SUPPORTING DESIGN STATEMENT

FOR NON-MATERIAL AMENDMENT TO PLANNING APPLICATION 180691

GREEN PARK VILLAGE PRIMARY SCHOOL - ALTERATIONS TO CAR PARK LAYOUT

1028-SS-22.01.19
VERSION 1.1

Figure 2. Amended Car Park Layout

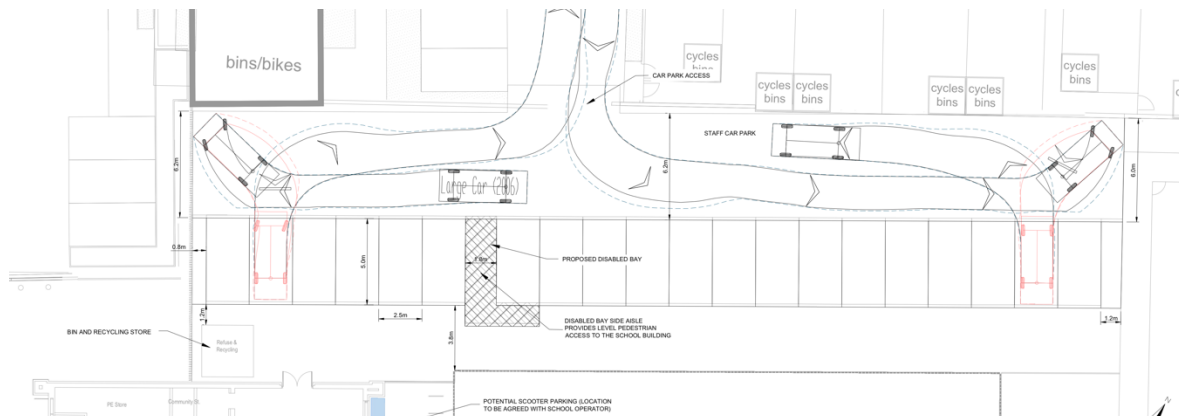
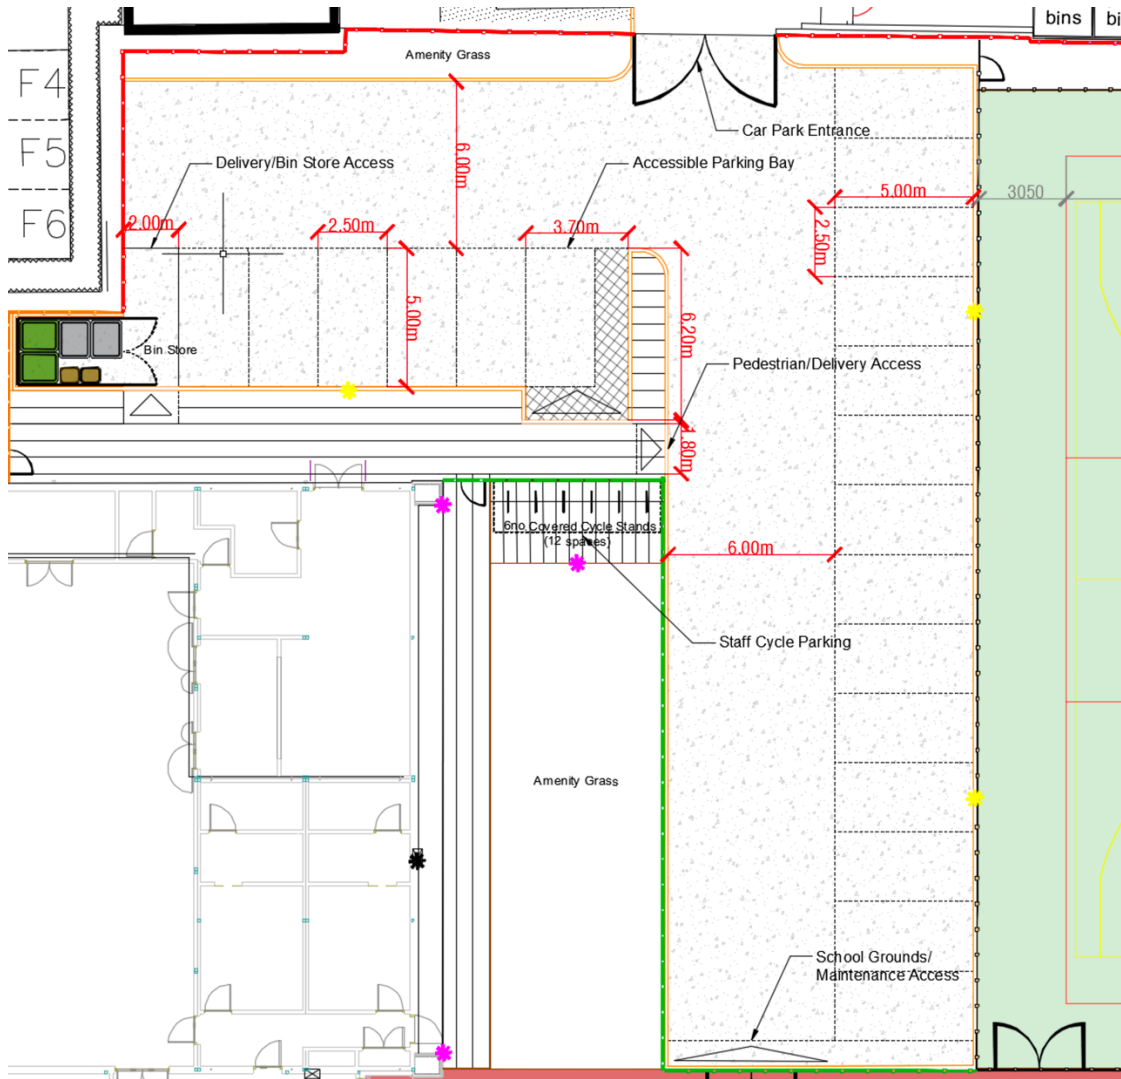
The staff car parking layout submitted with the application on 25th April 2018 (drawing 27310-A-2FE-02-100-P03, see appendix 1) provided 20 no bays measuring 5.0m x 2.5m (including one disabled bay), see figure 1. The 20 bays were originally laid out side by side in a linear arrangement with no gaps or spaces between bays. This presented a number of constraints not least in terms of access for deliveries and maintenance vehicles to both the school and grounds once all the bays were fully occupied (ie the only access would be between parked cars).

Should this car park arrangement be maintained a further reduction in the number of bays or a complicated arrangement of how bays are managed would be required to maintain access to the school and grounds via this access. It therefore seemed logical to investigate an alternate arrangement that may overcome the above noted operational issues whilst maintaining the same number of parking bays.

Figure 2 above shows the amended car park layout which has been achieved by re-orientating the MUGA sports area to allow two blocks of parking bays perpendicular to one another. The parking bays measure 5.0m x 2.5m with one block of six spaces (including disabled bay) adjacent to the school building and a further block of 14 spaces adjacent to the MUGA sports area (a ball stop fence will protect cars from the adjacent sports activities).

The two blocks of parking bays are separated by a revised internal road layout leading to the school grounds which is 6.0m wide. This provides improved access and turning for cars, HGVs, Fire Appliances and Refuse vehicles. Vehicle tracking is shown in Appendix 3.

Clear uninterrupted access is now available to the school grounds, to the school building and to the bin store without a reduction in the number of parking bays.
